Re: Oneida County Sewer District  
Water Pollution Control Plant and Sauquoit Creek Pump Station Evaluation

Consent Order No. R6-20060823-67

**ADDENDUM NO. 1  
TO  
WATER POLLUTION CONTROL PLANT AND  
SAUQUOIT CREEK PUMP STATION EVALUATION**

ADDENDUM NO. 1 TO  
WATER POLLUTION CONTROL PLANT AND  
SAUQUOIT CREEK PUMP STATION EVALUATION

**FIGURE 8-1**  
**HYDRAULIC ANALYSIS OF EXISTING SCPS CAPACITY**

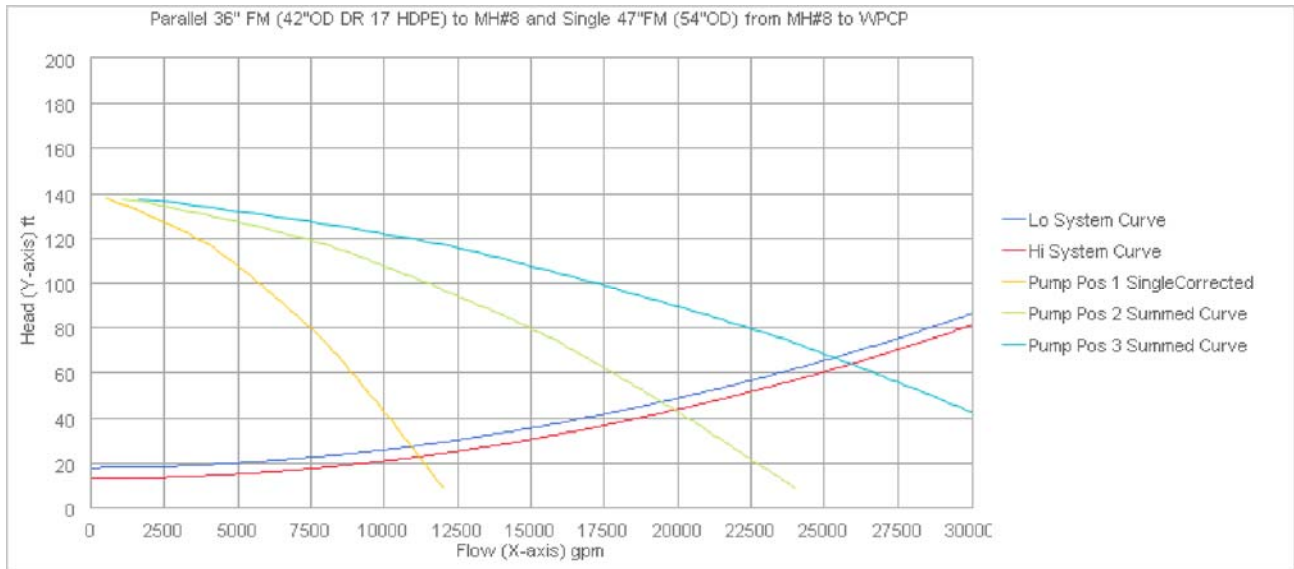
**NYSDEC Comment No. 16:** *Page 8-1, Section 8.1.1, SCPS Pumps – The SCPS currently has three operating pumps to convey 15 mgd of sanitary sewer to the WPCP. The Report calls for the SCPS to convey 35 mgd as part of the SSO elimination and proposes to accomplish this by increasing the Force Main capacity and utilizing the three pumps in operation. TSS Article 42.31 prescribes that "units shall have capacity such that, with any unit out of service, the remaining units will have capacity to handle the design peak hourly flow." Please provide data demonstrating that two pumps in the SCPS can convey 35 mgd to the WPCP. Should this not be possible, please provide an evaluation of providing a fourth pump in the SCPS or some other means to ensure peak flow (35 mgd) will be conveyed to the WPCP with one of the current three units down. Since the SCPS is the location of the current SSO, lack of reliable conveyance*

*capacity at this facility is directly opposed to the goal of the Order.*

The wording on page 8-1 has been modified to reflect that there are actually four pumps in the pump station, and that three can be operated concurrently. The fourth pump serves as a redundant backup. Language in this section has also been modified to clarify that two pumps in operation provide the current 15 mgd peak flow from the SCPS.

Hydraulic analyses show that with three (3) of the existing pumps operating the required hydraulic conditions with an increase in FM capacity (see Figure 8-1). The alternatives analysis determined a parallel 36-inch DR 17 high density polyethylene (HDPE) FM will provide the best benefit over costs, as compared to adding pump capacity. Additional information on the forcemains is presented in Section 8.2.

FIGURE 8-3  
SCPS FM TERMINUS JUNCTION BOX

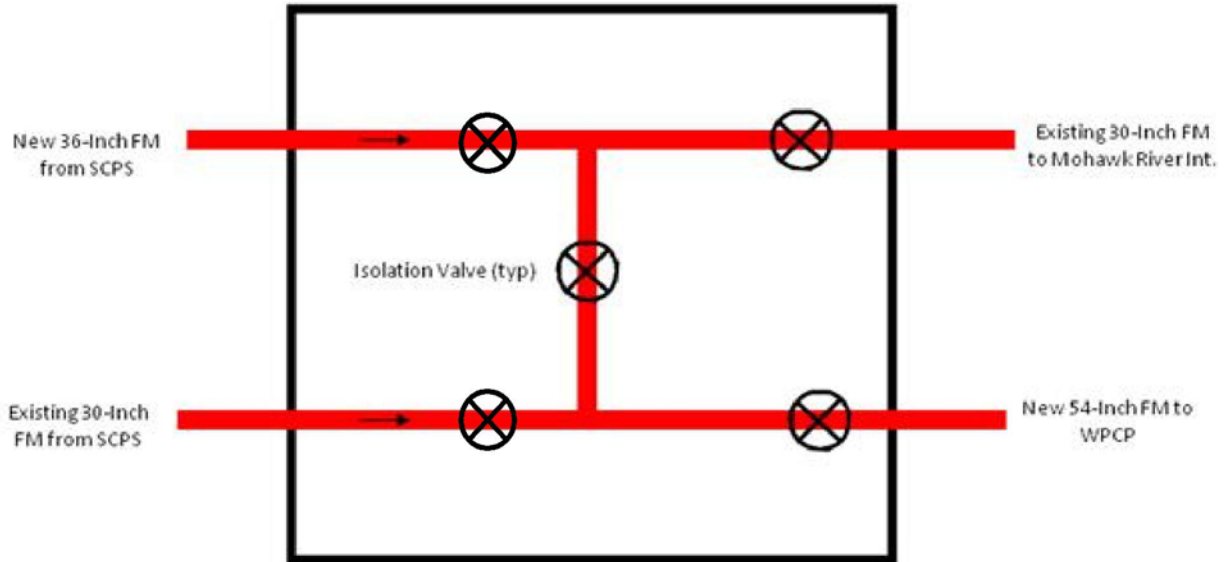
**NYSDEC Comment No. 17:** *Page 8-4, Section 8.1.3, SCPS Vaults – The text and Figure 8-3 indicate that the potential will exist for sanitary flow from the SCPS to be diverted to the MRI. That scenario is what currently exists as the sanitary sewage from the SCPS transitions from the force main to the gravity interceptor, comingles with the combined flows from the City of Utica, and provides for wet weather discharges from the City of Utica CSOs. It is understood that the District has no intention of eliminating the SSO by diverting the sanitary sewage out the CSO, and as such, language should be added to clarify the utilization, including how and when, of discharge to the MRI. Sanitary sewage in the MRI will also require clarification in the County's responses to Comment 11 and Comment 12 above.*

Section 8.1.3 has been updated to clarify that discharged to the Mohawk River Interceptor should only occur if the new 54-inch force main is damaged or being cleaned or repaired. Updated Section 8 is included at the end of this Addendum and supersedes the text in the August 2012 Report.

The valve which isolates the Mohawk River Interceptor from the SCPS must remain closed unless the new 54-inch force main is being cleaned or in need of repair. Cleaning should only

be done during periods of low flow, when there is no possibility of CSOs occurring along the Mohawk River Interceptor.
